809 BROOKLYN STREET
GLENWOOD-BROOKLYN
HISTORIC DISTRICT (HOD-S)

Nature of Project:
Construct two residential buildings

APPLICATION FOR A CERTIFICATE OF APPROPRIATENESS – STAFF REPORT

128-18-CA 809 BROOKLYN STREET

ELEVATION

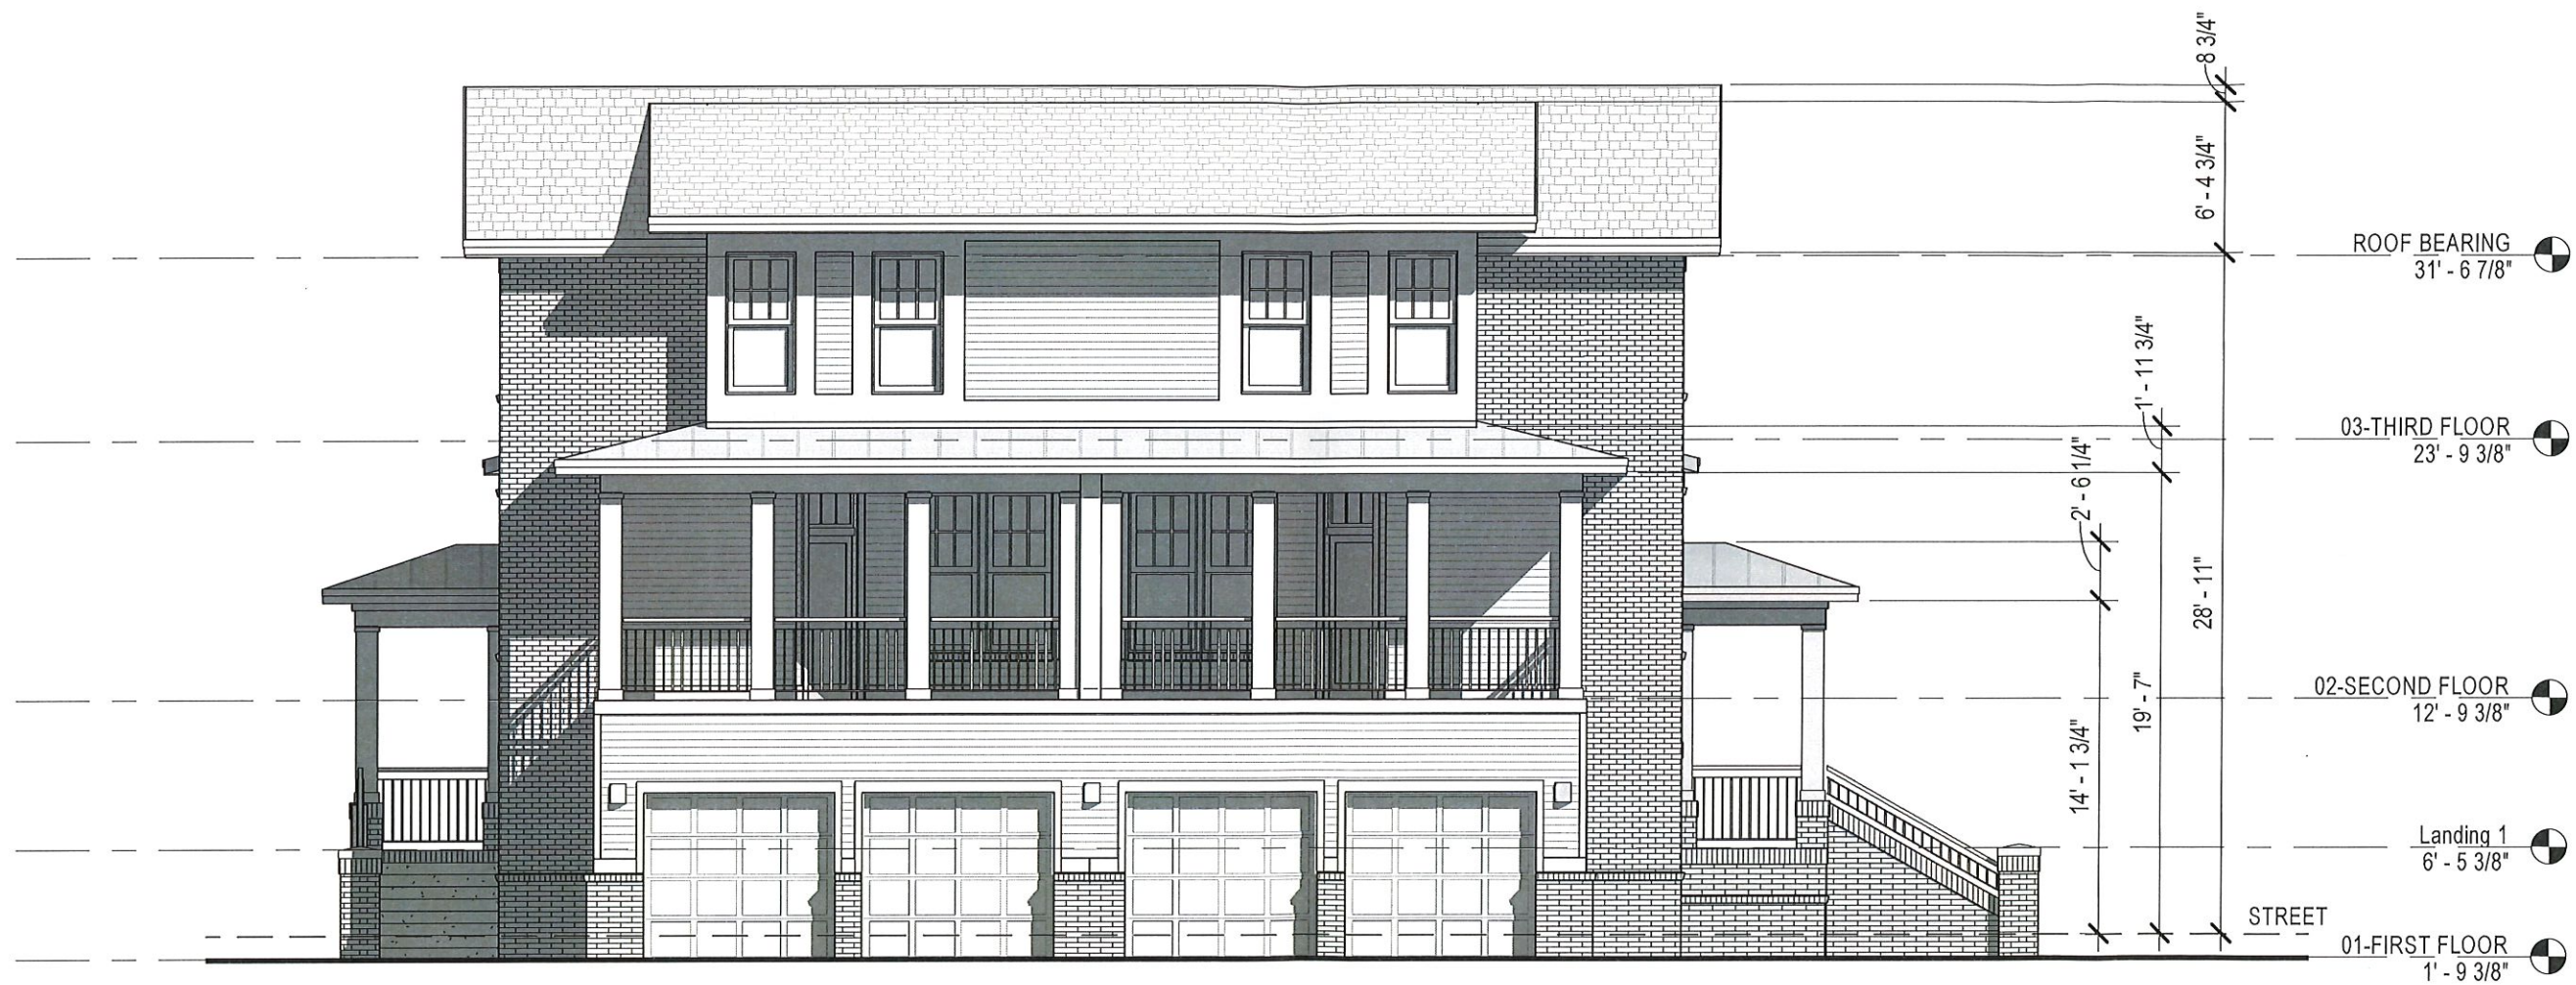
- 19* A double-length vertical window is proposed above the entry. The length is atypical of the district.
- 20* The majority of windows are proposed to be 6-over-1 in style.

1. That the windows either be wood or aluminum-clad wood.
2. That the window located on the above the entry porch be redesigned to be more congruous.
3. That details and specifications for the following be provided to and approved by staff prior to issuance of the blue placard:
 - a. Window and door units;
 - b. Eave construction;
 - c. Foundation details;
 - d. Porch details
4. That details and specifications for the following be provided to and approved by staff prior to installation or construction:
 - a. Curb cut;
 - b. Detailed driveway and parking plan;
 - c. Window and door trim;
 - d. Brick size and bond pattern for foundation, trim, and façade;
 - e. Siding specifications and reveal;
 - f. Railing specifications;
 - g. Roofing materials;
